INSERVICE TESTING PROGRAM
REVISION 14
SAN ONOFRE NUCLEAR GENERATING STATION
UNIT 2

April 1990

INSERVICE TESTING PROGRAM
SAN ONOFRE - UNIT 2

TABLE PR-8
RANGES FOR TEST PARAMETERS

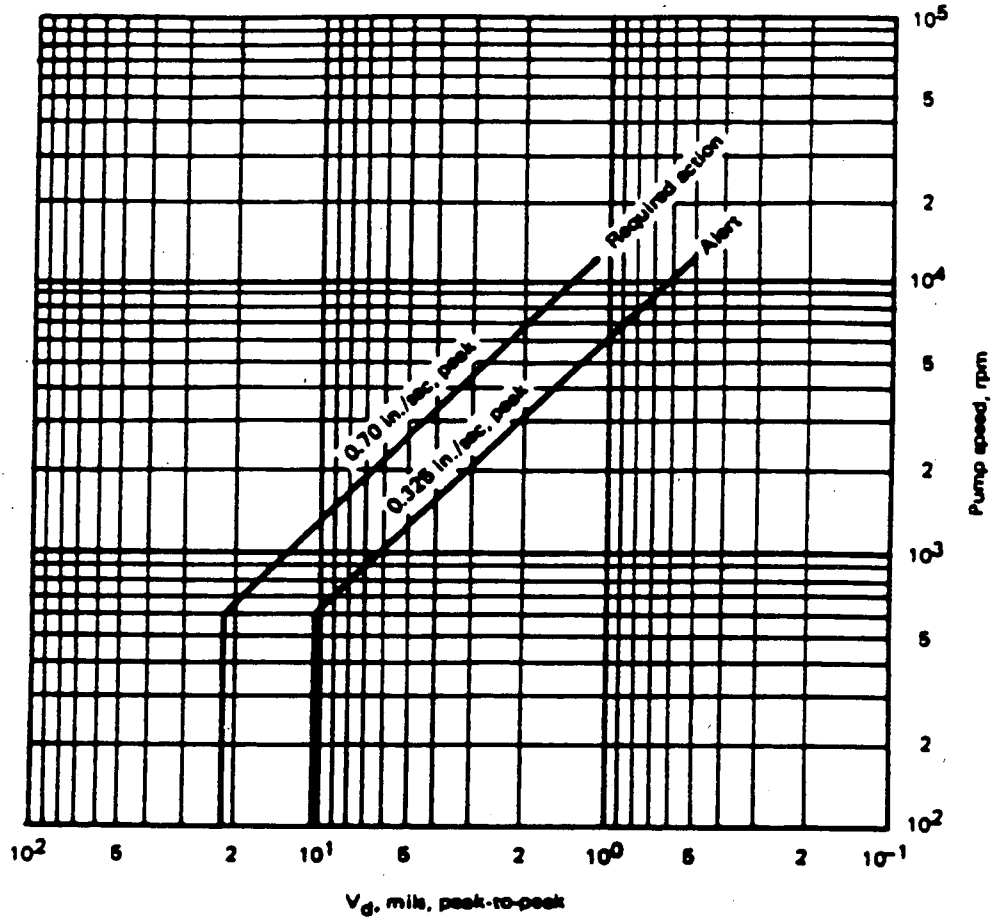
Alternate
Testing:

Perform IWP tests with station instruments for the pump parameters discussed above. Use the requirements of OM-6 for velocity vibration acceptance criteria as shown on the attached Table PR-8.
